Re: BZA2006-43: Zoning Adjustment to reduce the parking requirement by 25% and reduce the compatibility setback from 25 to 17 feet in "LC" Limited Commercial zoning, generally located north of Merton and east of Meridian (1650 S Meridian).

SITE PLAN BCHA 2006-43

REQUEST FOR VARIANCE, 1650 S. MERIDIAN, WICHITA, KANSAS
PARKING STALL REQUIREMENT VARIANCE
COMPATIBILITY SETBACK VARIANCE (EAST SIDE)
LANDSCAPE ORDINANCE VARIANCE

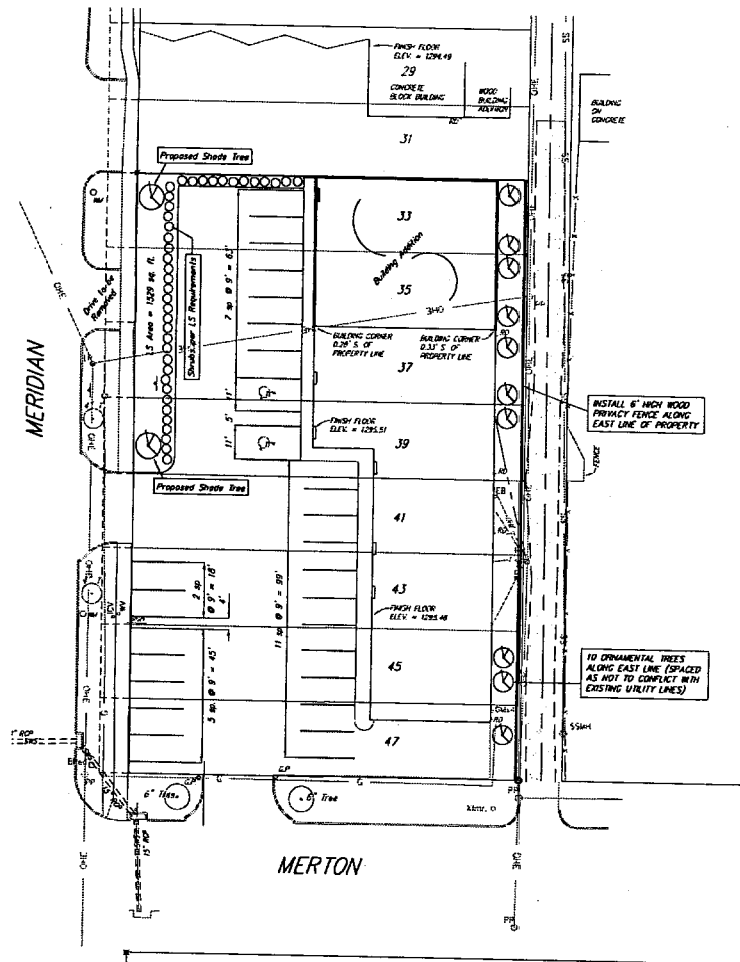
- 1) Impact on safety and convenience of vehicular and pedestrian circulation: The proposed reduction in parking requirement and compatibility setback should not have a detrimental impact on the safety and convenience of vehicular and pedestrian circulation in the vicinity of the application area. Sufficient parking should be available for the anticipated need, and the parking does not interfere with public right-of-way.

- 2) Impact on existing uses in surrounding areas: The proposed reduction in parking and compatibility setback should not impact existing uses in surrounding areas, as all parking for this project should be adequately provided on the site.

- 3) Compatibility with existing or permitted uses on abutting sites: A reduction of nine parking spaces should not compromise existing or permitted uses on abutting sites, as all parking for this project should be adequately provided on the site. The compatibility setback reduction on the site should be compatible with residences east of the site, as proposed screening and landscaping should mitigate the setback reduction.

- 4) Effect on public health, safety or welfare: There will be no encroachment into public right of way or utility easements; therefore there should be no impact on the public's safety, health or welfare.

We have reviewed your Zoning Adjustment request to reduce the parking requirement and compatibility setback on the above-referenced property. From reviewing your application we understand that you propose to construct an addition to an existing building on the site. Your site plan indicates 27 parking spaces, a 25% reduction of the 36 spaces required by the Unified Zoning Code (UZC). Your site plan also indicates a 17-foot setback from the alley centerline west of the building, an 8-foot reduction of the UZC required 25-foot compatibility setback. Therefore, you have requested a Zoning Adjustment to reduce the parking requirement to 27 spaces, and reduce the compatibility setback to 17 feet.

Sec. V-I.2.i. of the Unified Zoning Code allows an adjustment to reduce the parking requirement by 25% when the conditions required by Sec. V-I.6. of the Code are met. We find that the reduction of the parking requirement as proposed meets the four conditions required by Sec. V-I.6. of the Code as set out below. Likewise, Sec. V-I.2.d. of the Unified Zoning Code allows an adjustment to reduce or

Our signatures below indicate that an administrative adjustment to reduce parking by nine spaces, from 36 to 27, and a compatibility setback reduction from 25 to 17 feet, is hereby granted for the aforementioned property subject to the following conditions:

- 1) The site shall be developed in general conformance with the approved site plan.
- 2) The parking area shall be paved and marked.
- 3) Any violation of these conditions shall render the Administrative Adjustment null and void.
